**BEFORE
THE OHIO POWER SITING BOARD**

In the Matter of the Application of	)	
Kingwood Solar I LLC for a Certificate	)	Case No. 21-0117-EL-BGN
of Environmental Compatibility and	)	
Public Need	)

**NOTICE OF RESPONSES TO DATA REQUESTS FROM
THE STAFF OF THE OHIO POWER SITING BOARD**

**KINGWOOD SOLAR'S OCTOBER 12, 2021 RESPONSES
TO STAFF'S SEPTEMBER 29, 2021 DATA REQUESTS**

- USER: dverrier - LAST SAVED: 10/7/2021 1:20:49 PM

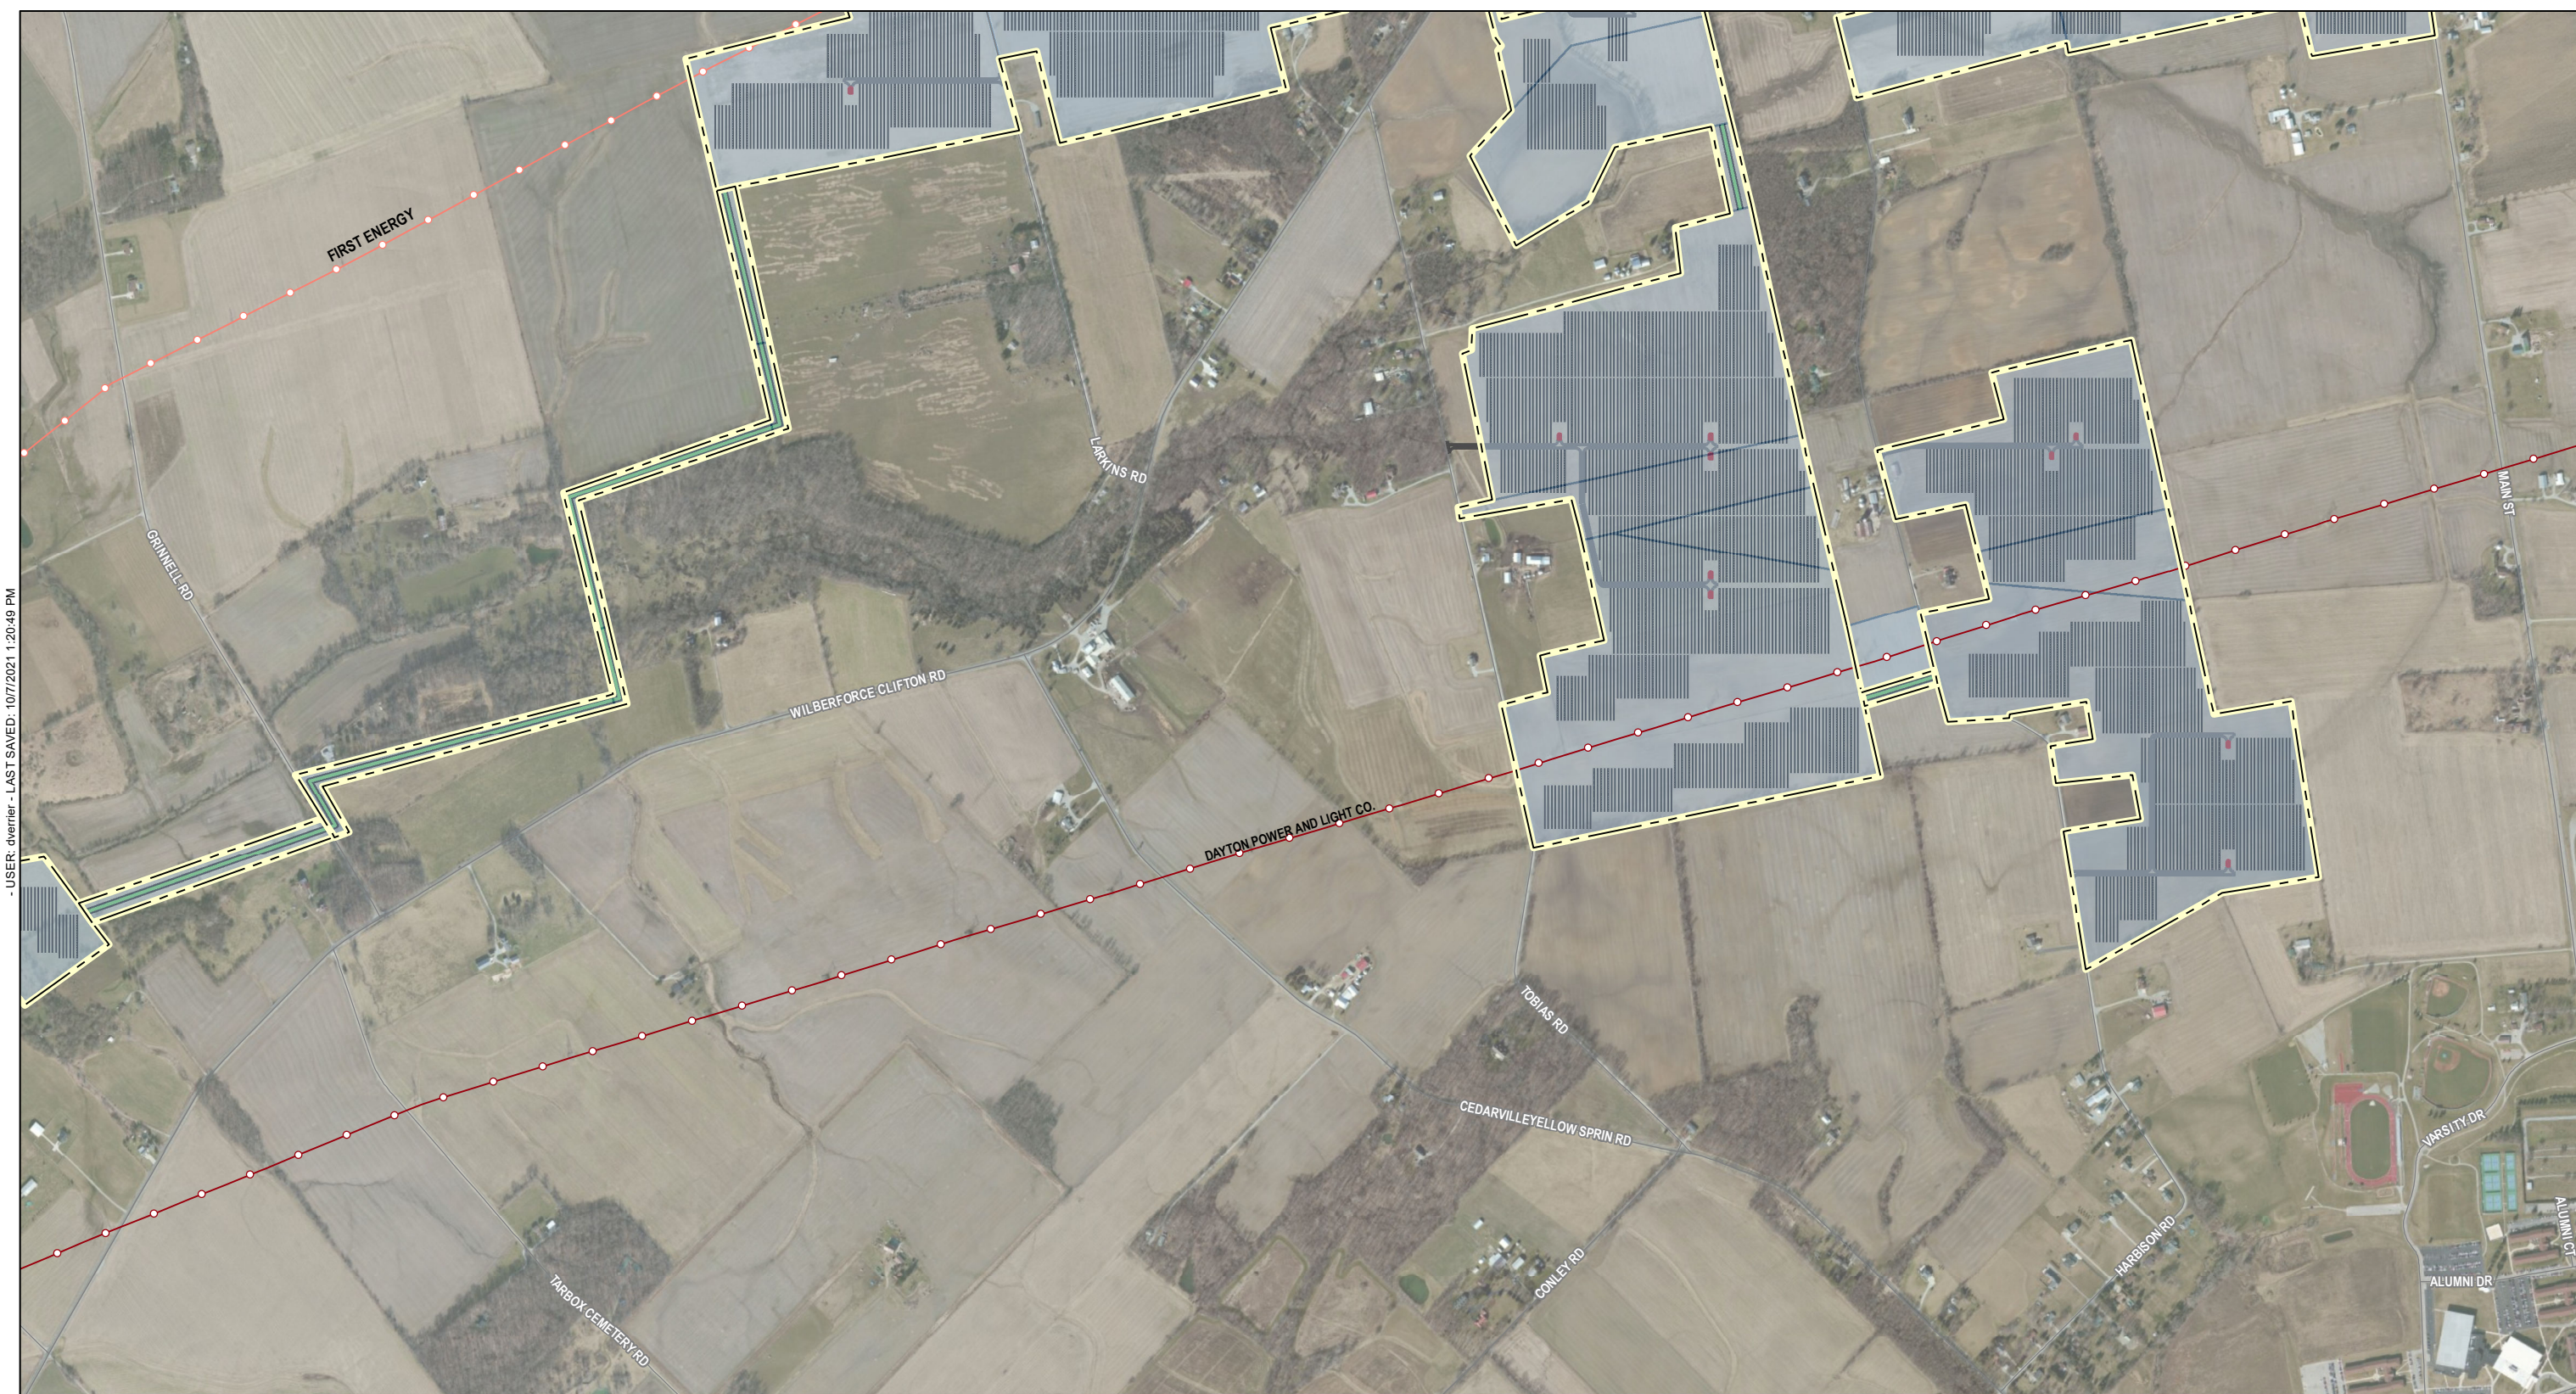
15. In follow up to Kingwood Solar's June 1, 2021 Responses to Staff's May 17 and May 20 Data Requests (DR#20) which included an updated Figure 03-3, the included Figure 03-3 doesn't depict the 200 feet of 138 kV gen-tie line but only a POI. Please provide an updated Figure 03-3 (Project Layout) and other relevant facility mapping that depicts the specific proposed location of the gen-tie line referenced on page 1 of the Application and provide associated shapefiles.

An updated version of Figure 03-3 is provided depicting the approximate location of the 200-foot 138-kV gen-tie mentioned on page 1 of the Application. This location may shift slightly depending on the final design of the interconnection facilities.
